ADDENDUM NO. 3

July 19, 2023

RE: **GS# 211-071**
Hayden Hall Renovations
Perkinston Campus
Mississippi Gulf Coast Community College
Perkinston, Mississippi
A/E Project No. 22-050

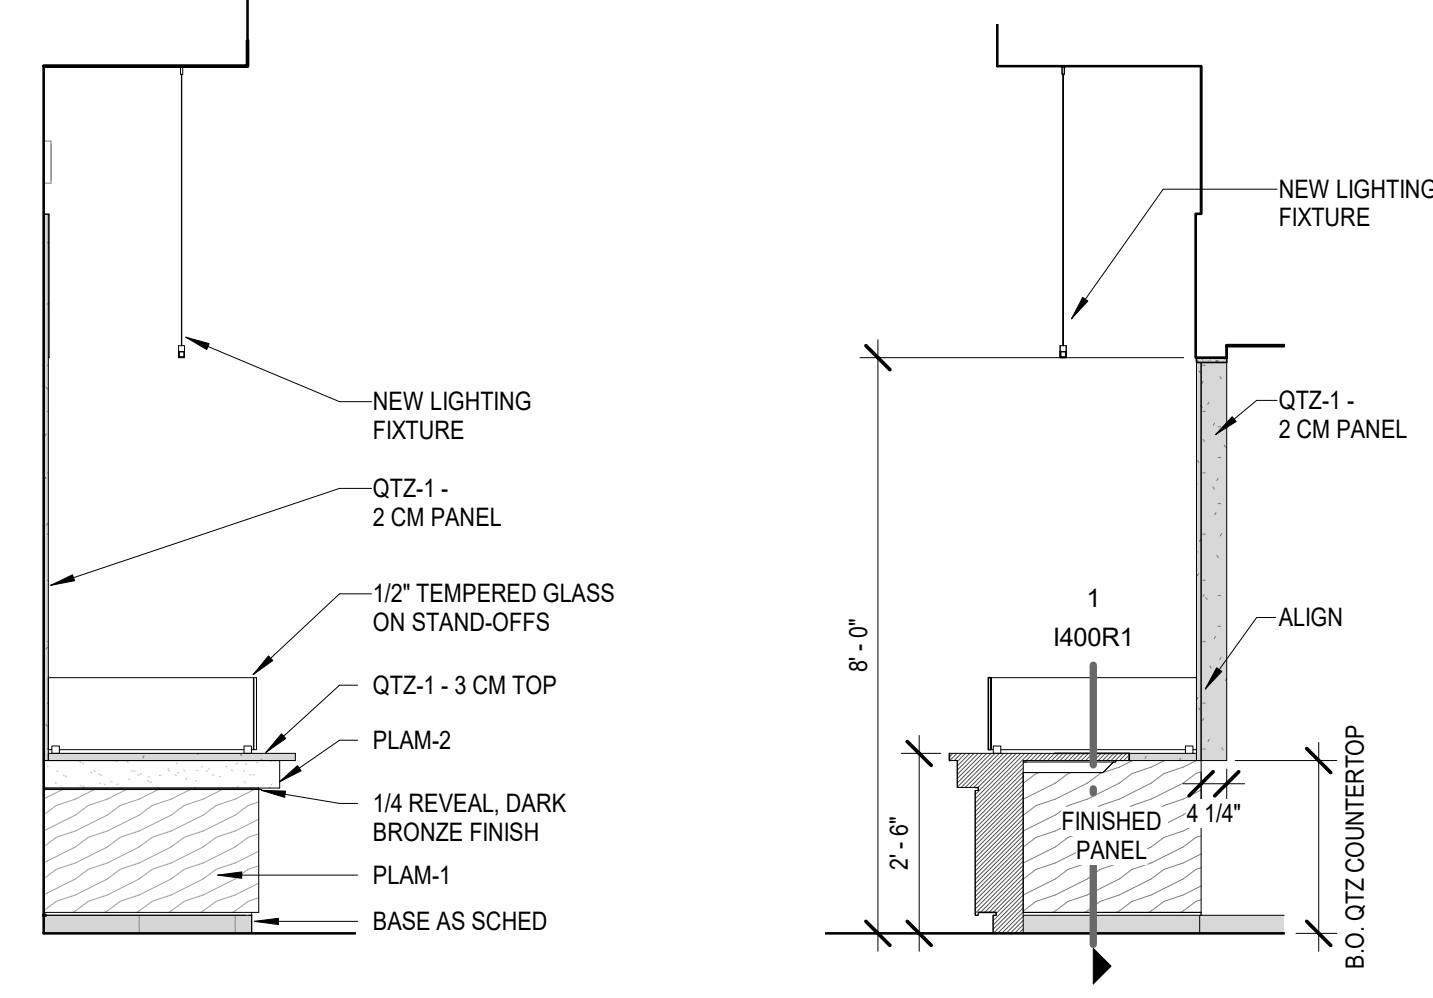
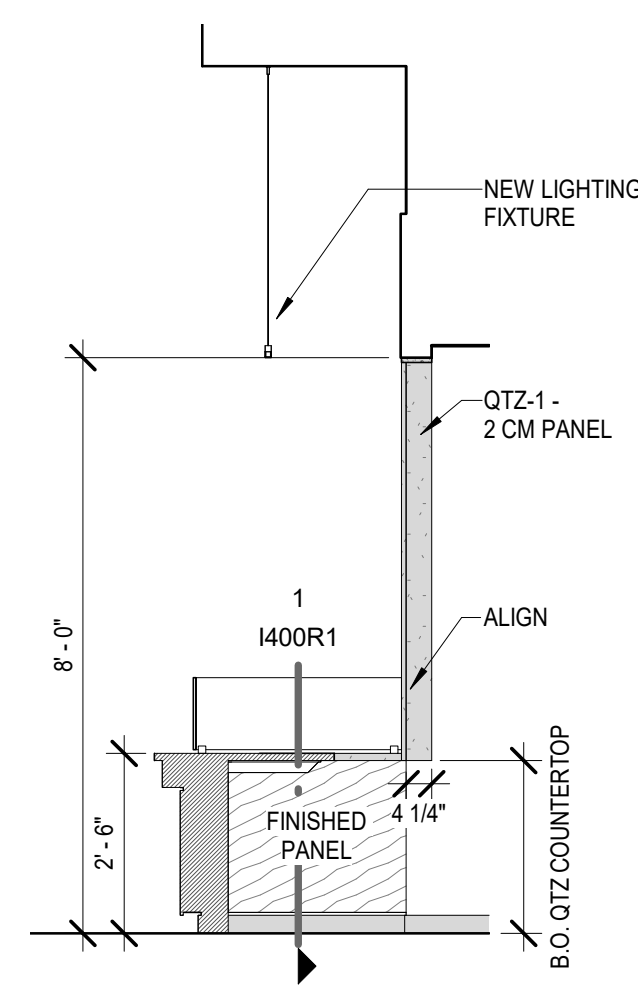
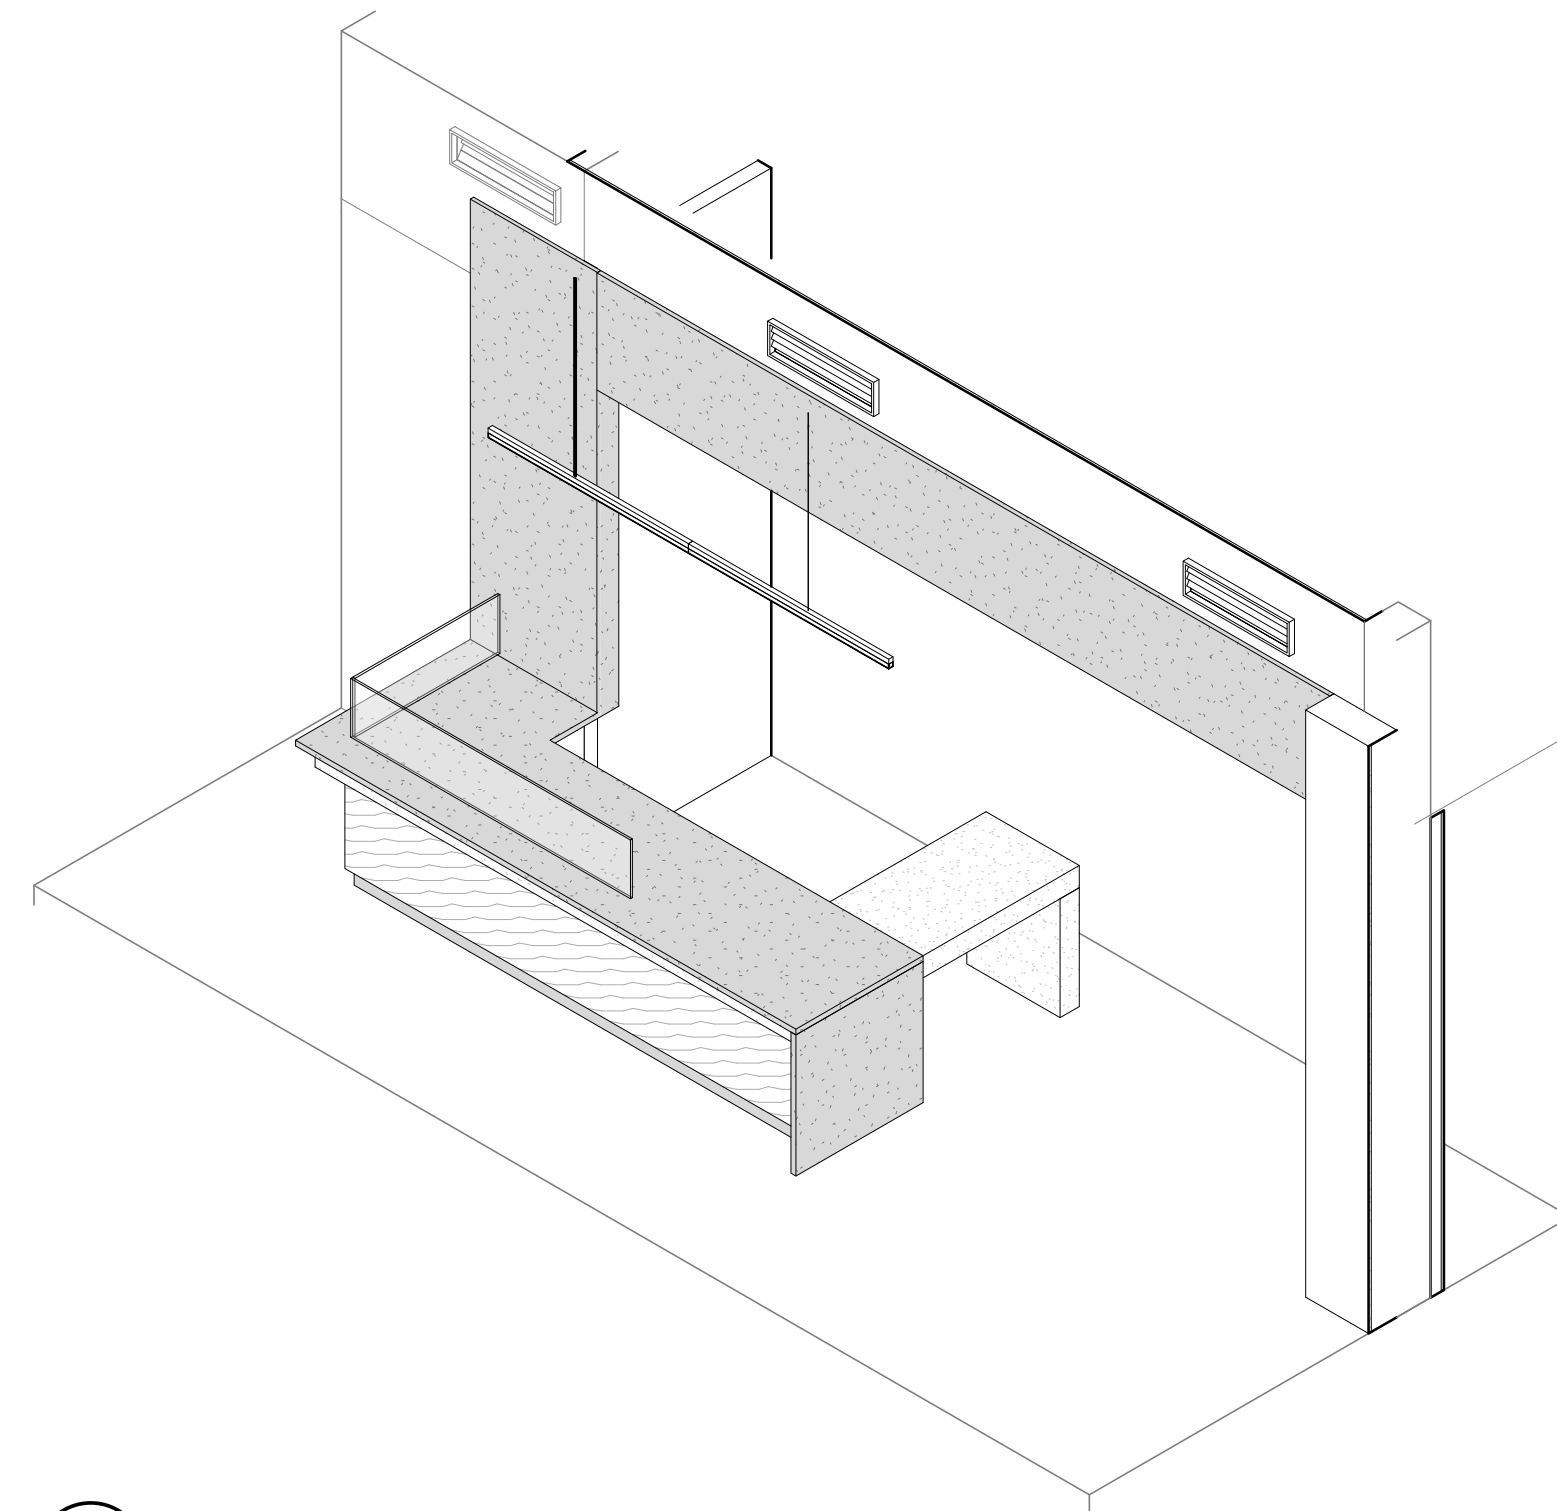
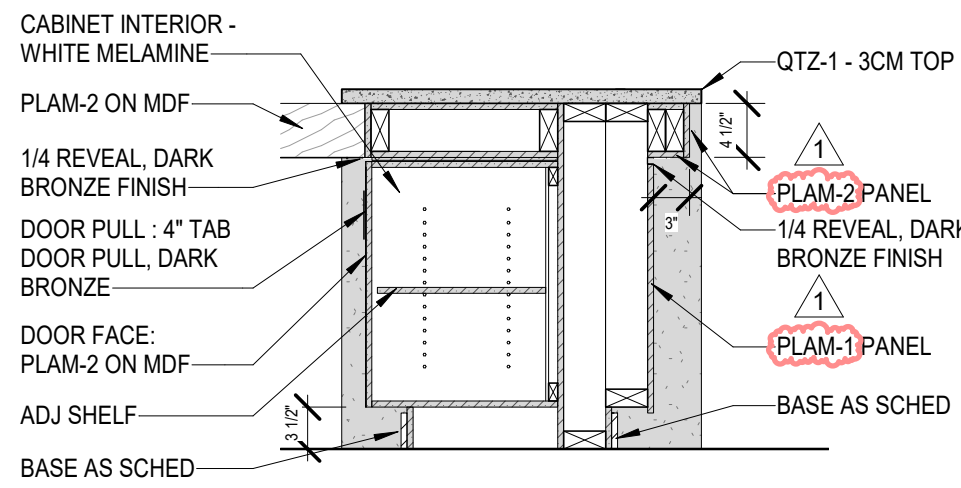
Q: Elevation 14/I200 & 13/I400 shows QTZ-1 for the wall panels & returns but sections 1 & 2/I400 shows QTZ-2. Elevation 10/I200 show QTZ-2 for counter top but section 4/I600 shows QTZ-1. Please verify all locations of QTZ-1 & QTZ-2 quartz materials

A: See attached for updated sheets.
